CITY of NOVI CITY COUNCIL

Agenda Item 1
February 25, 2019

SUBJECT: Approval at the request of McBride Dale Clarion for the Speedway at 14 Mile and Haggerty, JSP 17-63, with Zoning Map Amendment 18.720, to rezone property in Section 1, located at the southwest corner of Fourteen Mile Road and Haggerty Road from OST (Planned Office Service Technology) and B-3 (General Business) to B-3 (General Business) subject to the Amended and Restated Planned Rezoning Overlay (PRO) Agreement and corresponding PRO Plan. The property totals 2.03 acres and the applicant is proposing to update and rebuild the whole site.

DRWG. NO: **2224-CG**

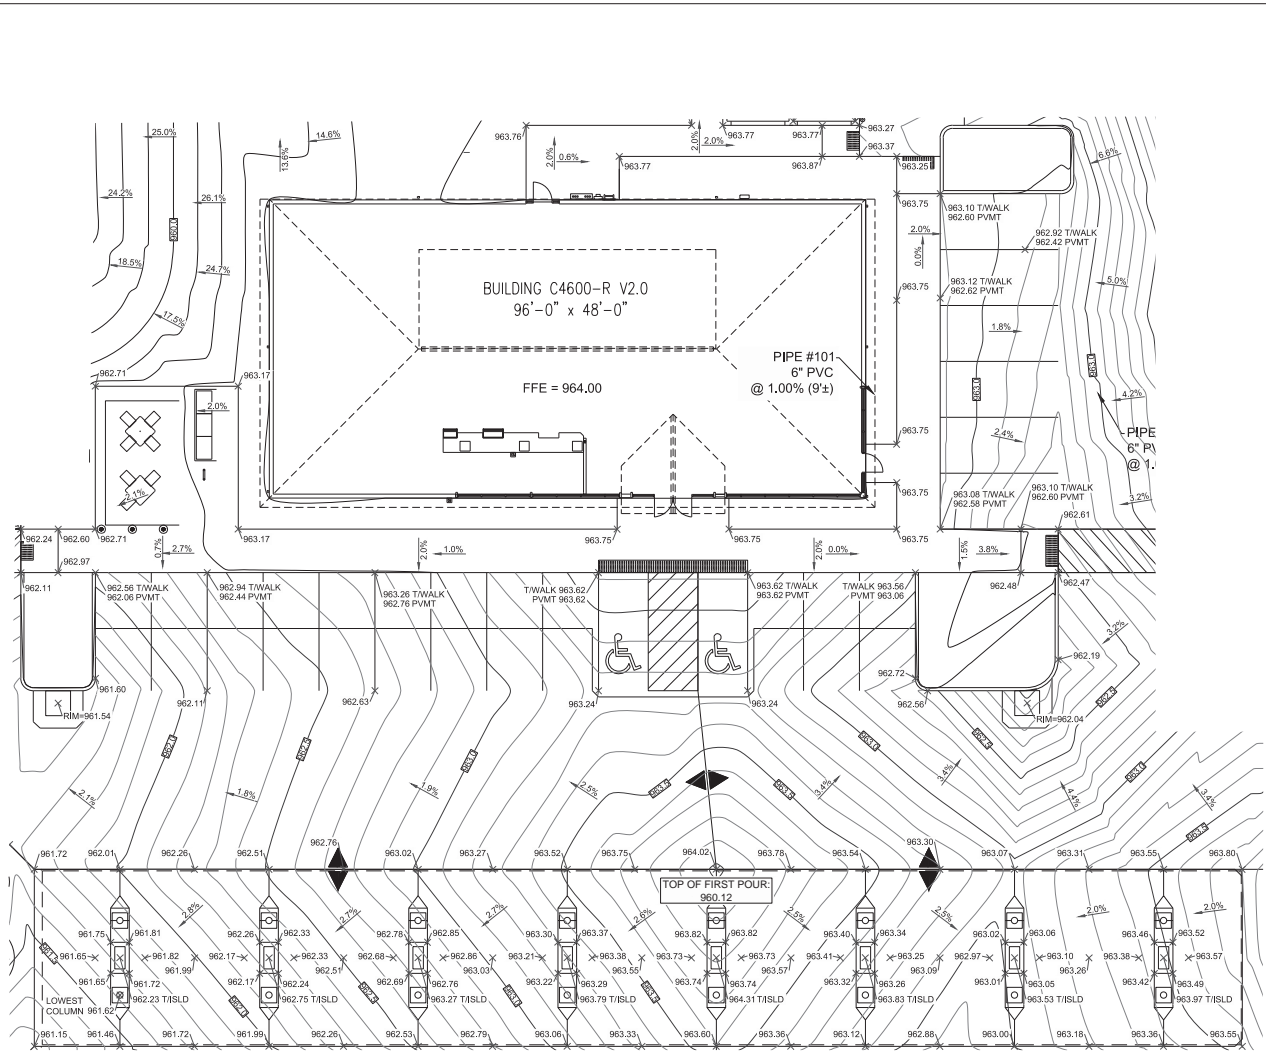
24. Clearly show the emergency overland flow route for the proposed basin. **Emergency overflow route will be added to sheet 2224-CG.**

26. Revise the grading plan to show limits of grading south beyond end of sidewalk with maximum 4:1 (25%) slope. **25% slope will be added to sheet 2224-CG for the limits of grading.**

2224 - CG1

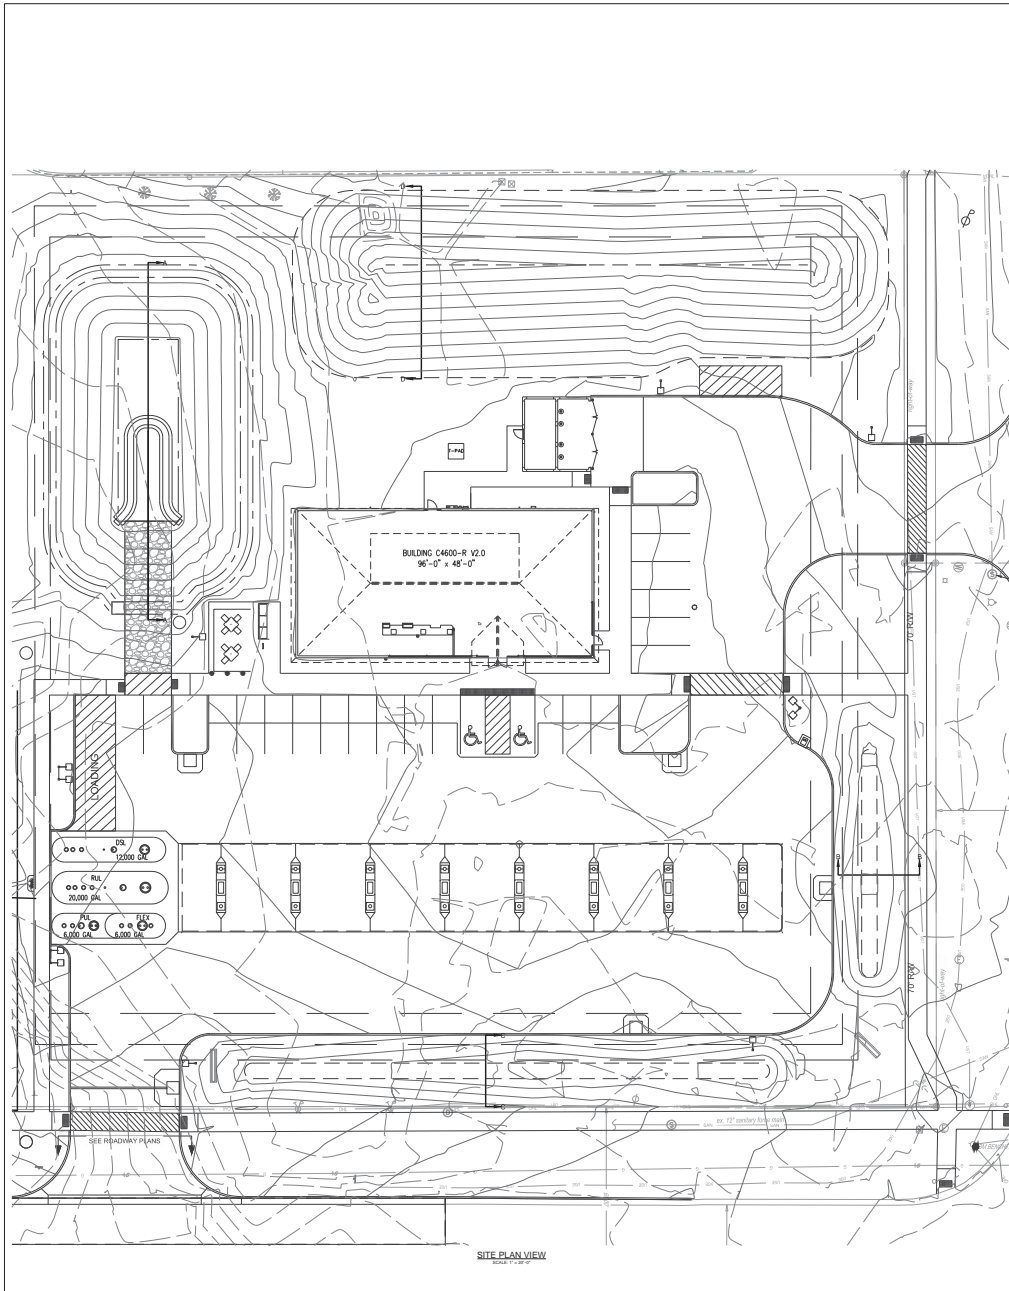
30. Provide top of curb/walk and pavement/gutter grades to indicate height of curb adjacent to parking stalls or drive areas. **Refer to sheet 2224-CG1.**

2224 - SWMP

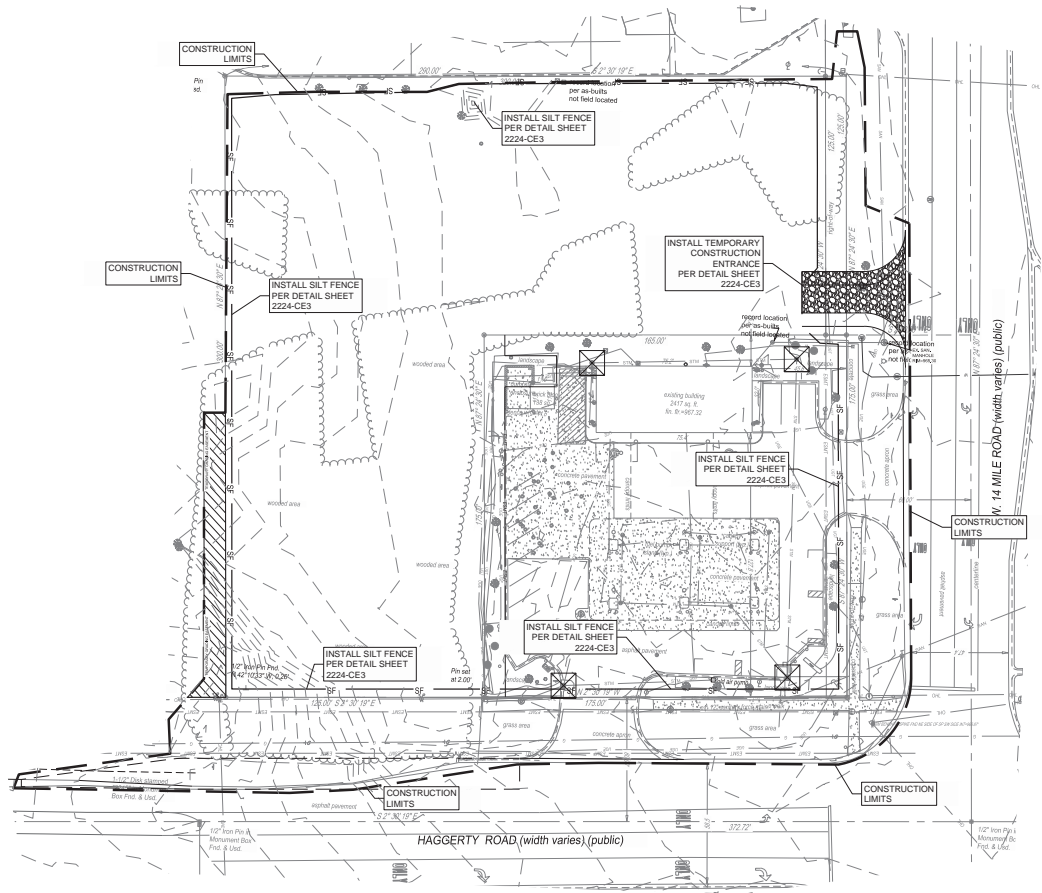
19. The Storm Water Management Plan for this development shall be designed in accordance with the Storm Water Ordinance and Chapter 5 of the new Engineering Design Manual. Refer to section 5.6.2 for pond geometry and location of inlet and outlet requirements. **Noted. Refer to sheet 2224-SWMP.**

DESIGN TEAM DATE
R. THORNTON 08/14/17
R. BAIRD 08/14/17
M. NIOSHANG 08/14/17
2224 - CU3

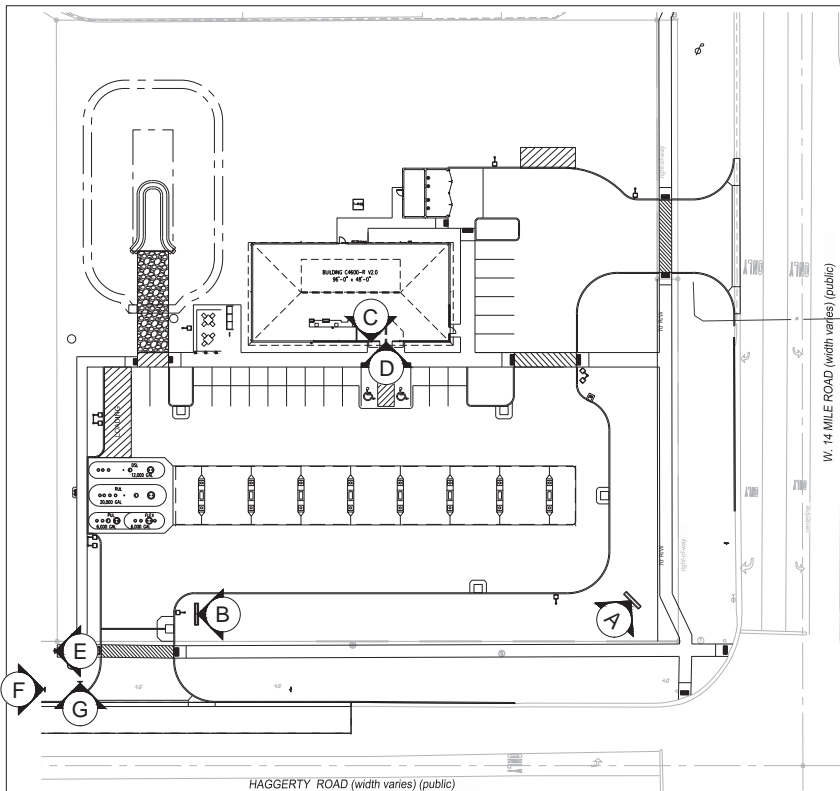
17. Provide a four-foot deep sump and an oil/gas separator in the last storm structure prior to discharge to the storm water basin. **Refer to the Aqua swirl detail on 2224-CU3**

20. Provide a cross-section for the proposed basin outlet. **Refer to outlet control structure detail on sheet 2224-CU3.**
21. Provide manufacturers details and sizing calculations for the pretreatment structure. Provide drainage area and runoff coefficient calculations specific to the area tributary to the treatment structure. The treated flow rate should be based on the 1-year storm event intensity (~1.6 In/Hr), resulting in a flow rate of approximately 2.35 CFS. Higher flows shall be bypassed. **See Aqua Swirl detail on sheet 2224-CU3. Sizing calculations will be provided on this sheet for this structure.**

23. Provide release rate calculations for the three design storm events (first flush, bank full, 100-year). **Refer to sheet 2224-CU3 for pond release rate calculations.**

2224 - SS

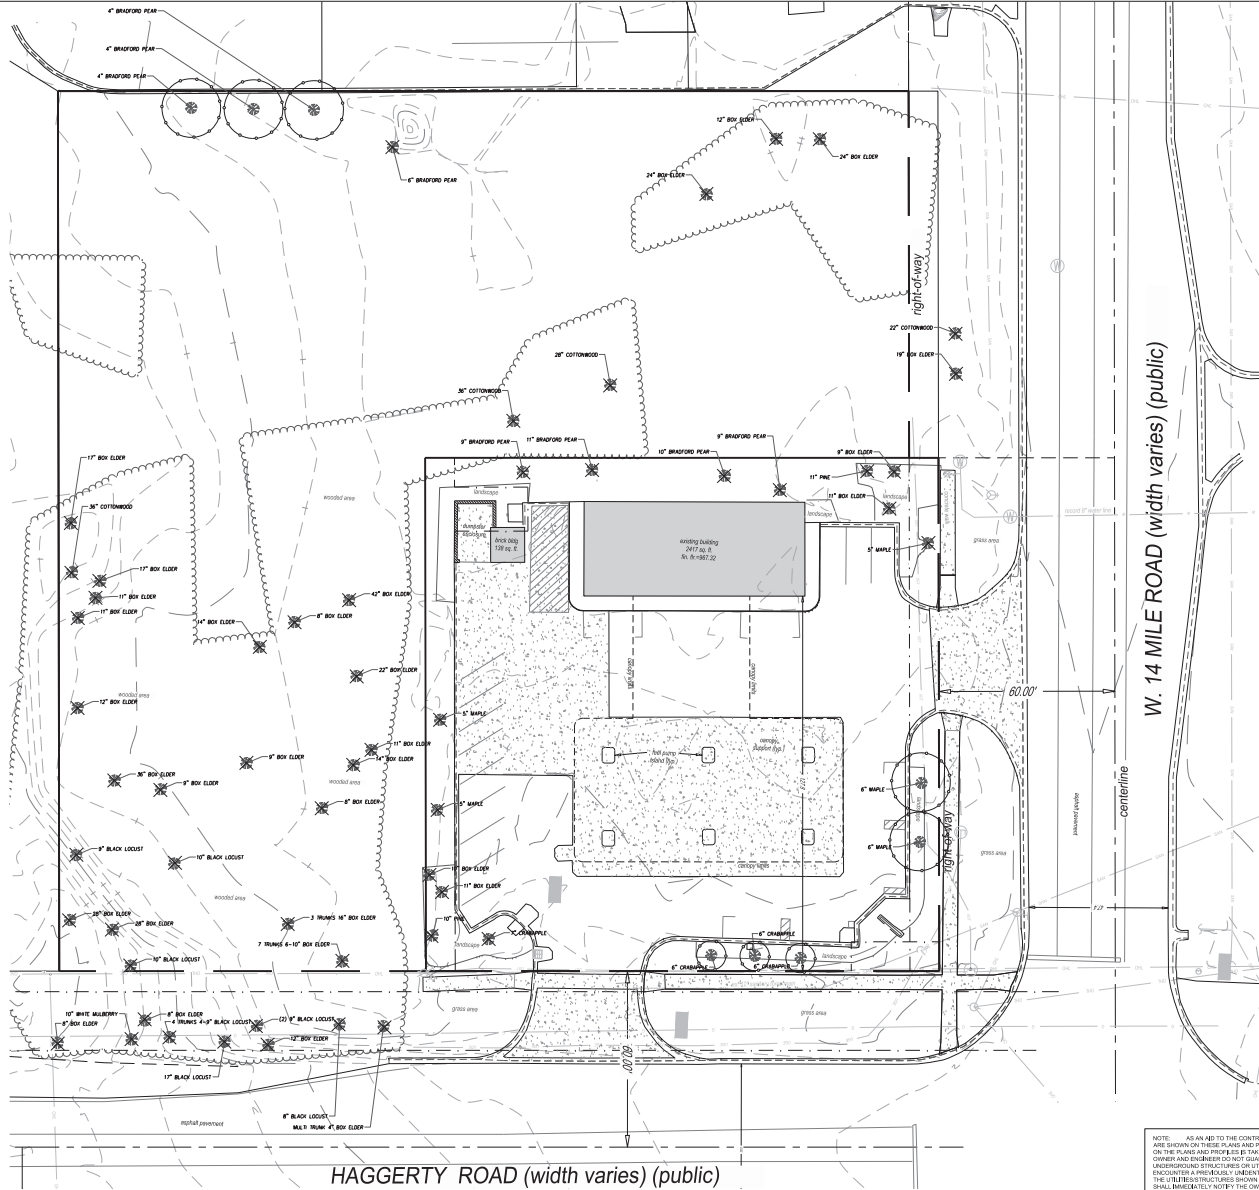
3. The applicant should provide signing quantities and details, including size, MMUTCD designation and post, in future submittals.
 4. The speed limit sign on sheet 2224-SS should be 45 MPH for Haggerty Road and not 50 MPH.
